# USE IF CABLE IS BEING MADE IN HOUSE

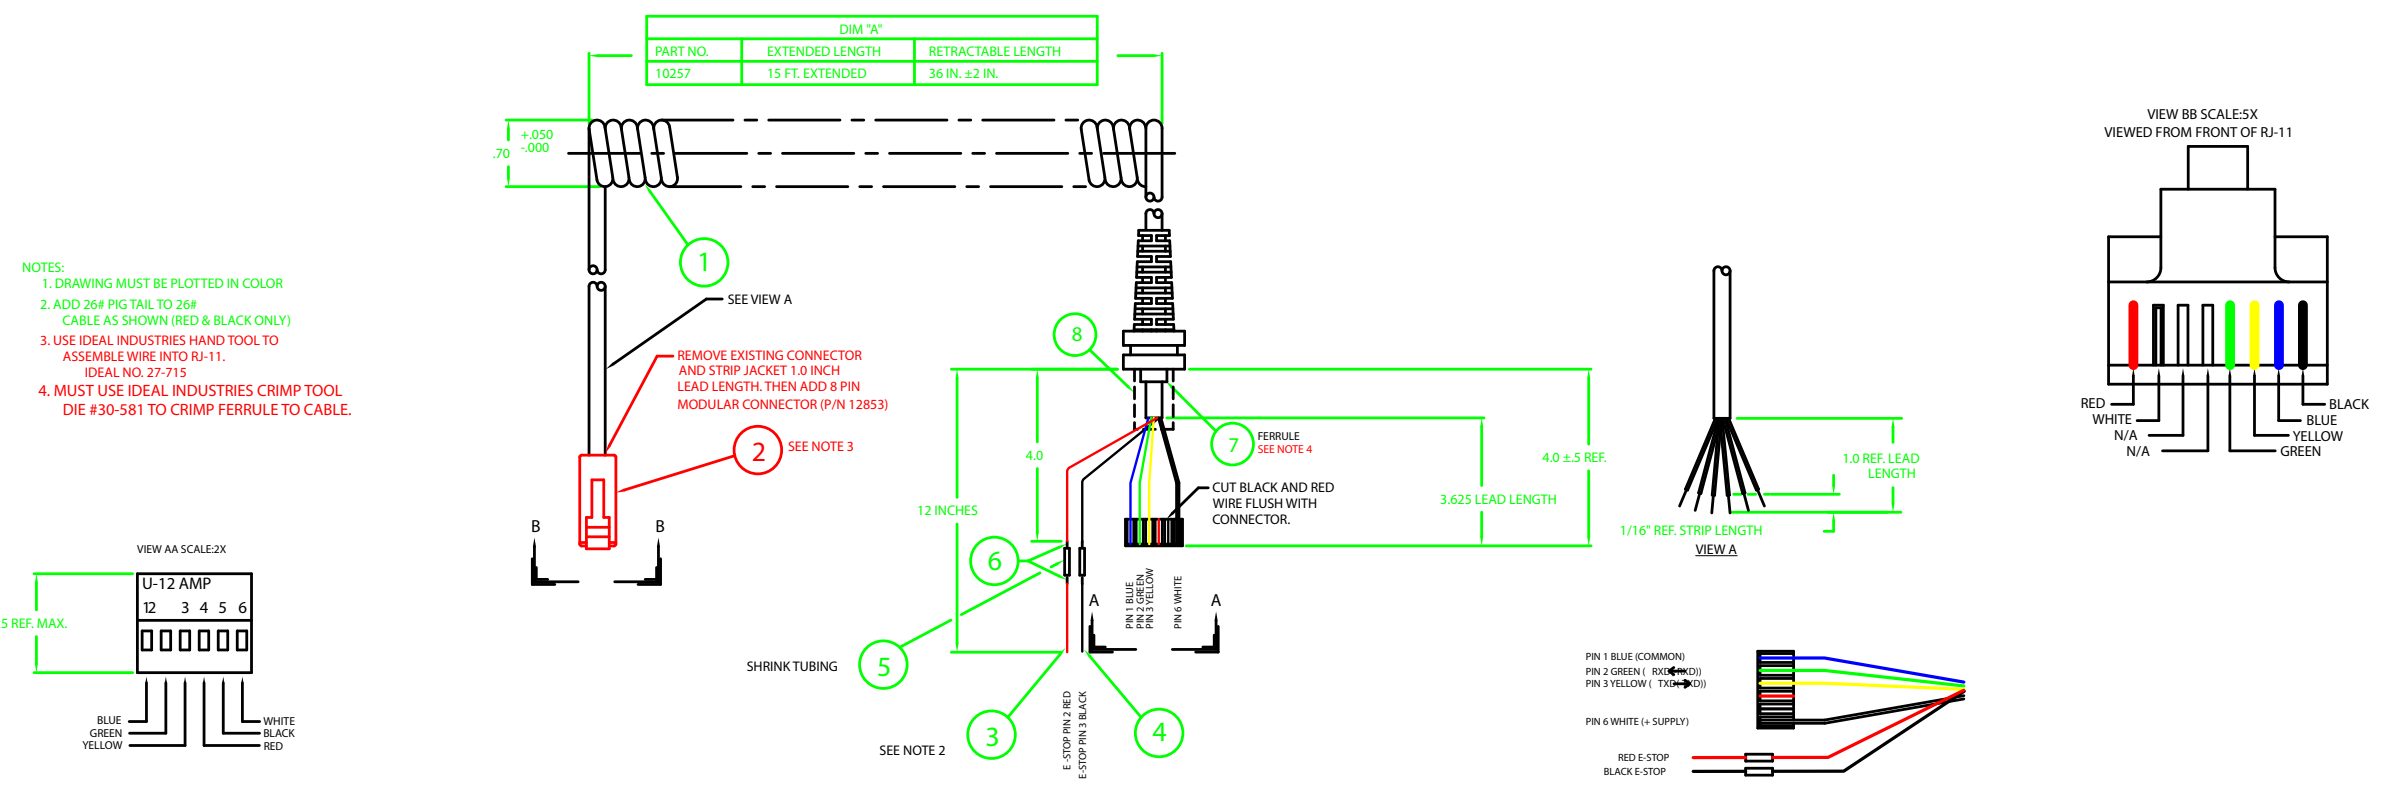
REVISIONS				
LTR	BY	DESCRIPTION	DATE	APPROVED
B	VT	REMOVED HIROSE CONNECTOR AND ADDED PAN PACIFIC CONNECTOR (ITEM 2)	4-20-98	VT
C	VT	CHANGED PAN PACIFIC PART NO. FROM PT-088KR/SOUL TO PT-0388R/SOUL & SHOWED PROPER LEAD LENGTH IN VIEW A	11-16-98	VT
D	VT	ADDED IN HOUSE INSTRUCTIONS FOR BUILDING CABLE.	11-23-98	VT
E	VT	CHANGED ITEM PART NO 12853 TO 13184 (ITEM 2)	11-24-98	VT
F	VT	CHANGED ITEM 2 TO 13235 FROM 13184 IN OVERSEAS BILL OF MATERIAL.	3-24-99	VT
G	VT	CHANGED LEAD LENGTH FROM 9" TO 12" IN DWG.	1-24-01	VT
H	VT	ADDED METAL FERRULE 13948 AND SHRINK TUBING 10351 TO CABLE.	3-10-03	VT
